**NRC RAI Letter Nos. ML19032A396 and ML19032A397 Dated February 1, 2019**

**Section I – Fluence**

### **RAI 3.5.2.2.2.6-1**

Figure 5.7. Effect of gamma radiation on the residual compressive strength of concrete. (Kontani et al. 2010)

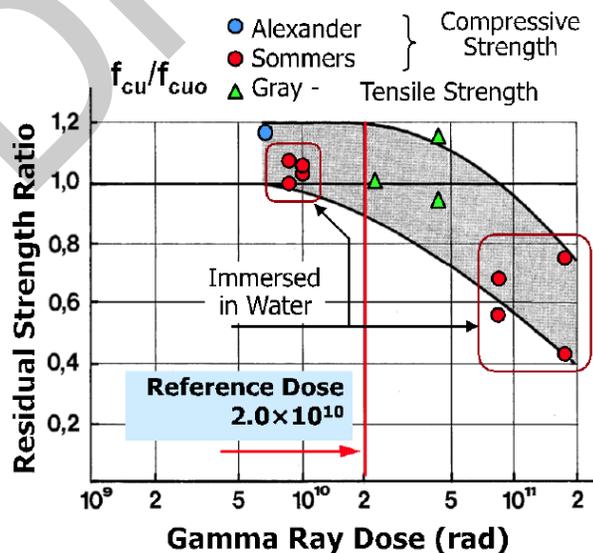
With regard to considerations such as the gamma dose rate, carbonation of concrete, aggregate, cement type, w/c ratio, and operating temperature of the concrete at PTN PSW versus the test specimens used in the Maruyama study: explain how the conclusions in Maruyama's paper can be used to assume that there is no degradation in material properties due to gamma dose, or provide justification for why such comparison between the PTN PSW and Maruyama study is unnecessary.

As noted in PTN SLRA 3.5.2.2.2.6, Rev. 1 (page 12 of 19 of the attachment to Reference 1), gamma irradiation up to  $2.3 \times 10^{10}$  rad likely has no effect on material properties of concrete. Additionally, NUREG/CR-7171 (Reference 2), Section 5.2 used  $2.0 \times 10^{10}$  rad (i.e.,  $2.0 \times 10^5$  kGy) as the critical level for gamma exposure when assessing the reduction of concrete strength under nuclear irradiation (as shown in Figure 5.7 excerpted and reprinted below from Reference 2). Concrete structures were considered to be sound as long as the level of radiation did not exceed this critical level.

This figure presents a plot, prepared by Kontani et al. (2010), of the same test data collected by Hilsdorf et al. (1978), showing the effect of gamma rays on the residual compressive and tensile strengths of concrete. In the figure, the reference dose is shown as  $2.0 \times 10^{10}$  rad.

Additionally, as noted in the response to RAI 3.5.2.2.2.6-2 (Attachment 2 to this letter), the Westinghouse-calculated gamma dose incident on the PTN PSW at the end of the SPEO is  $1.44 \times 10^{10}$  rad. The dose calculated by FPL for the gamma dose used in the concrete degradation evaluation was  $1.9 \times 10^{10}$  rad incident on the PSW at the end of the SPEO. Considering the very conservative gamma dose used in the concrete degradation evaluation, and the  $2 \times 10^{10}$  rad critical level from NUREG/CR-7171, concrete degradation due to gamma radiation of the PTN PSW is not expected through the SPEO.
